ADDENDUM NUMBER ONE

**RMS & FRMS GYMS, WHHS BLDG Y & HCPS C.O. ROOF REPLACEMENTS
HENDERSON COUNTY PUBLIC SCHOOLS**

MLA PROJECT NUMBER: 20004

DATE OF ISSUE: June 29, 2020

**BUILDING Y
ROOF PLAN-
WEST
HENDERSON
HIGH**

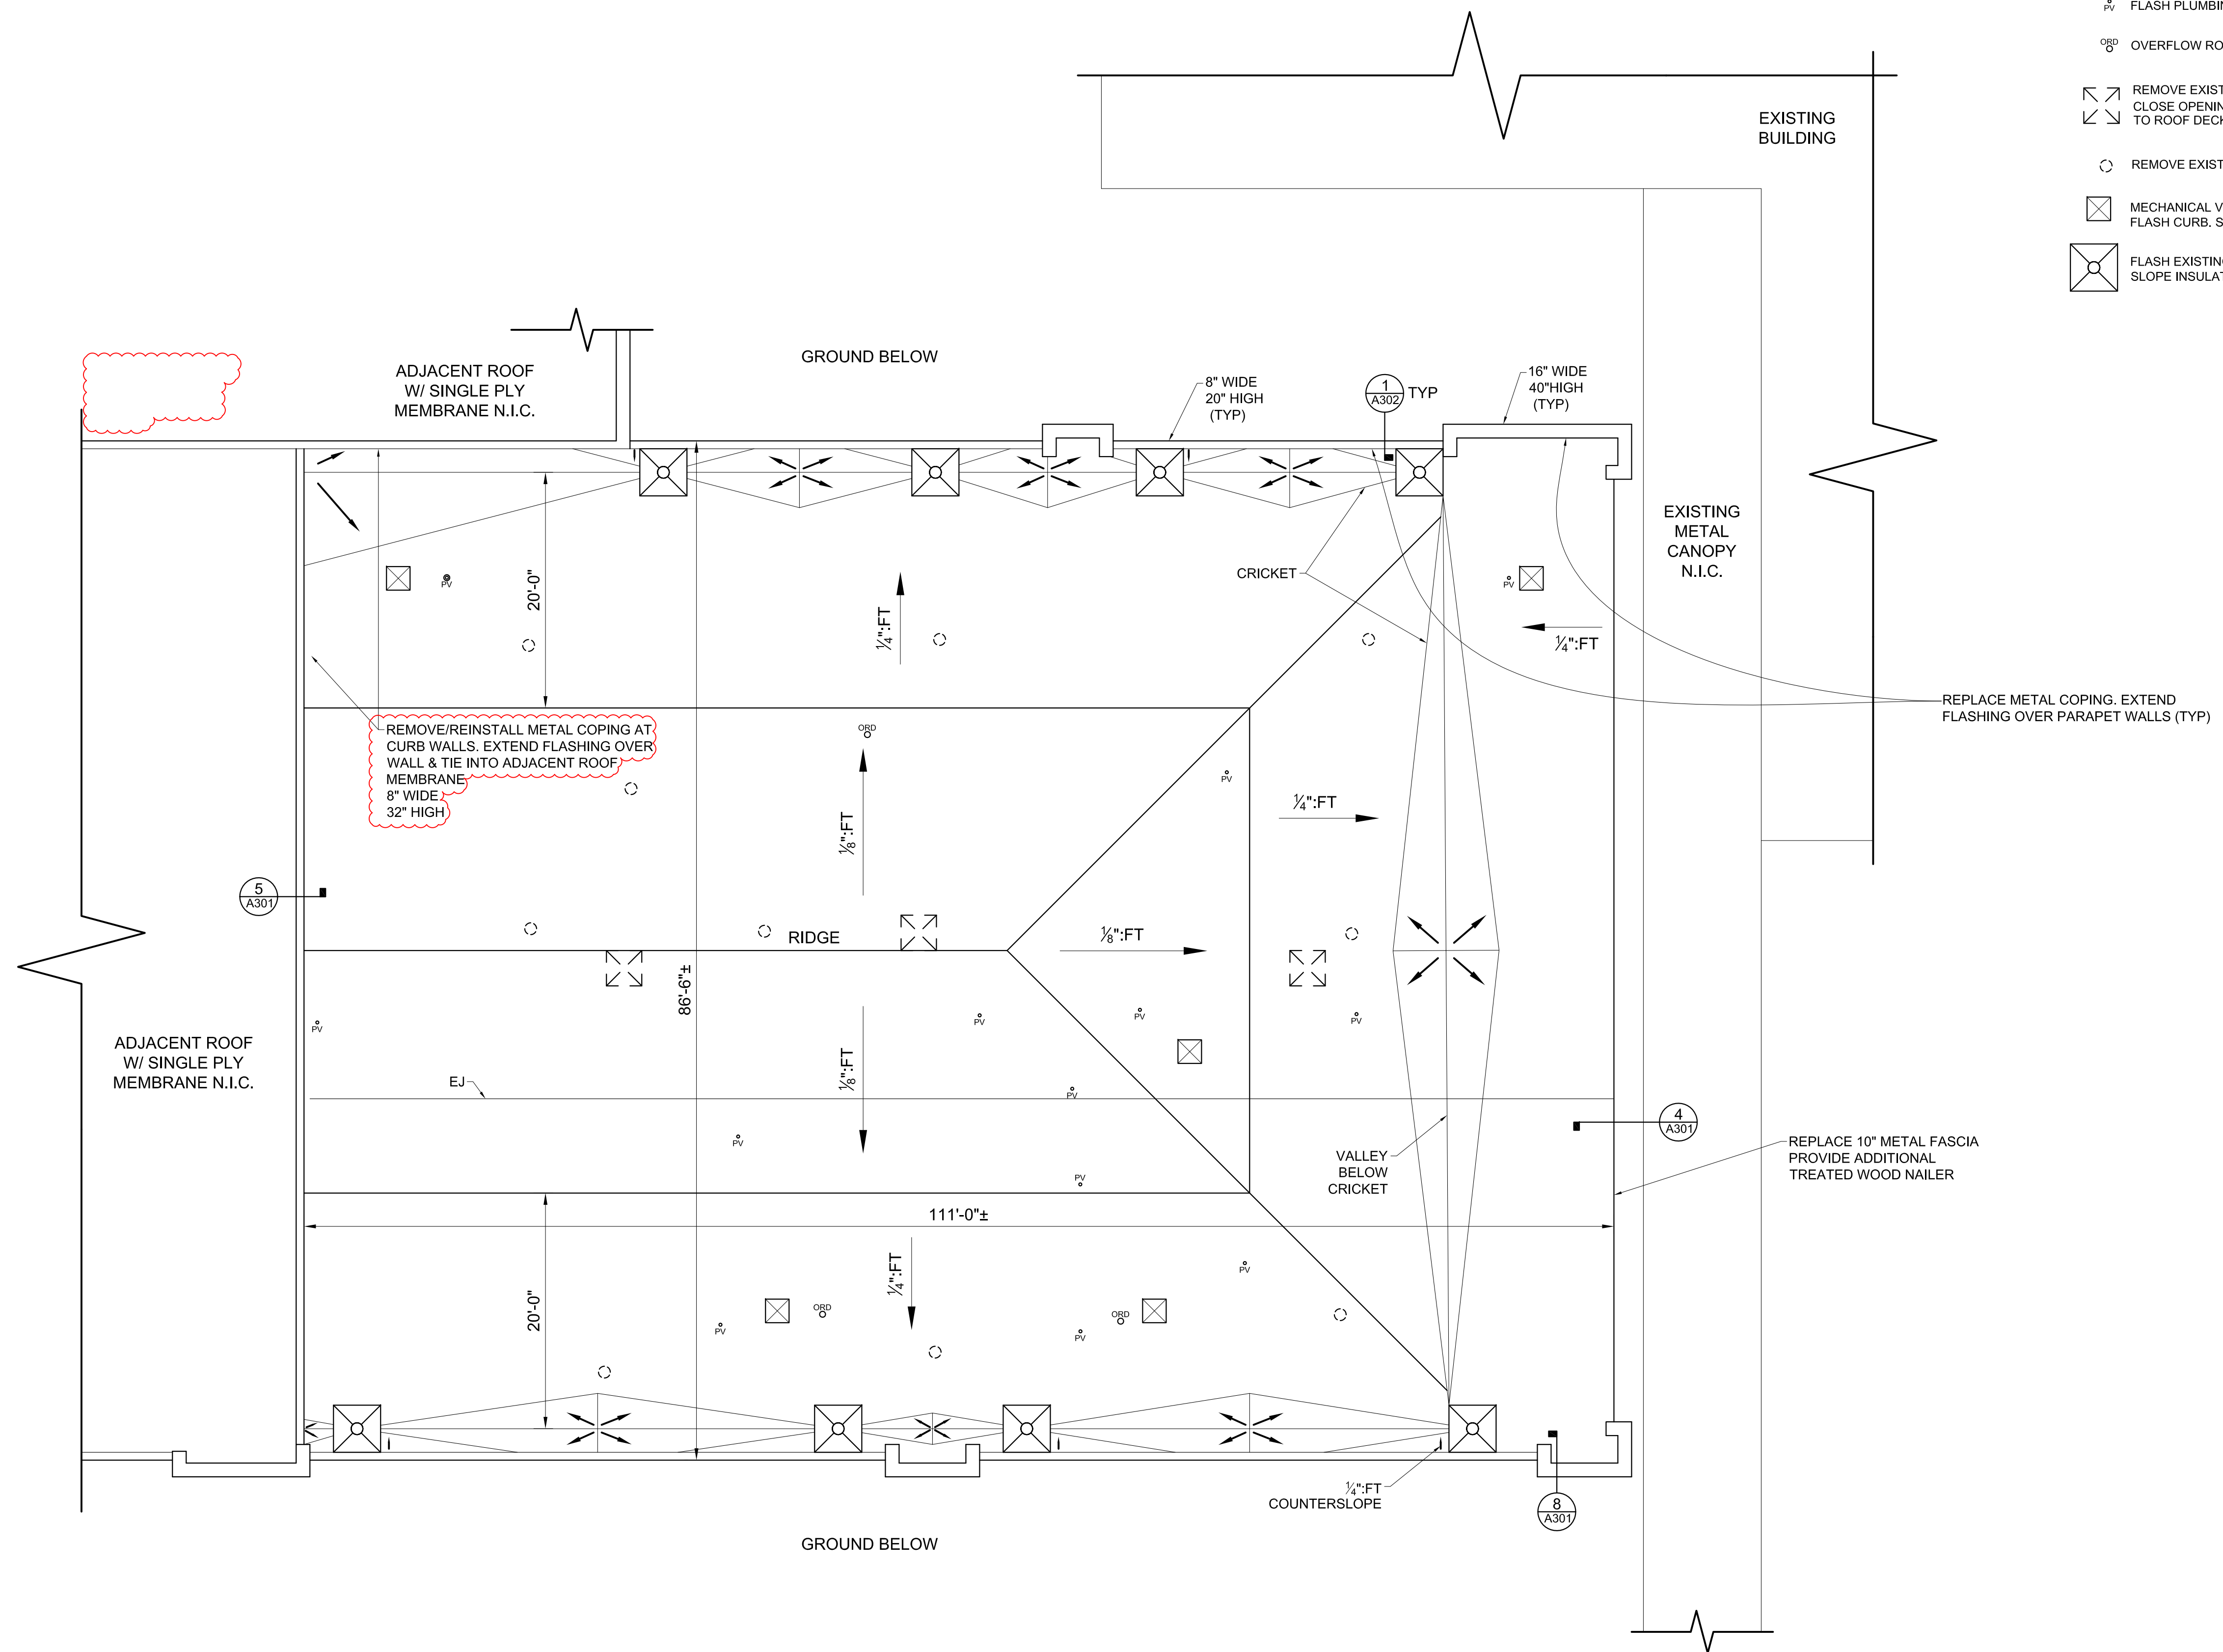
1. A201: See attached for revisions
2. A203: See attached for revisions
3. A204: See attached for revisions
4. A205: See attached for revisions
5. A301: See attached for revisions

Project Number: 20004
Checked:
Drawn: A. Rognas
Date: 6/22/20
Revisions:
Addendum 1: 6/29/20

2. DEMOLITION: REMOVE ALL EXISTING ROOFING COMPONENTS DOWN TO VAPOR BARRIER. REMOVE EXISTING ROOFING SYSTEM COMPONENTS INCLUDING TERMINATION BARS, FLASHING. THE EXISTING VAPOR BARRIER SHALL REMAIN.

3. PROVIDE FULLY ADHERED 60 MIL TPO MEMBRANE ROOFING SYSTEM, AND TAPERED INSULATION OVER EXISTING VAPOR BARRIER. ATTACH TAPERED INSULATION THROUGH INTO EXISTING CWFD.

4. MINIMUM INSULATION THICKNESS AT RD'S & VALLEY'S SHALL BE 2.6"
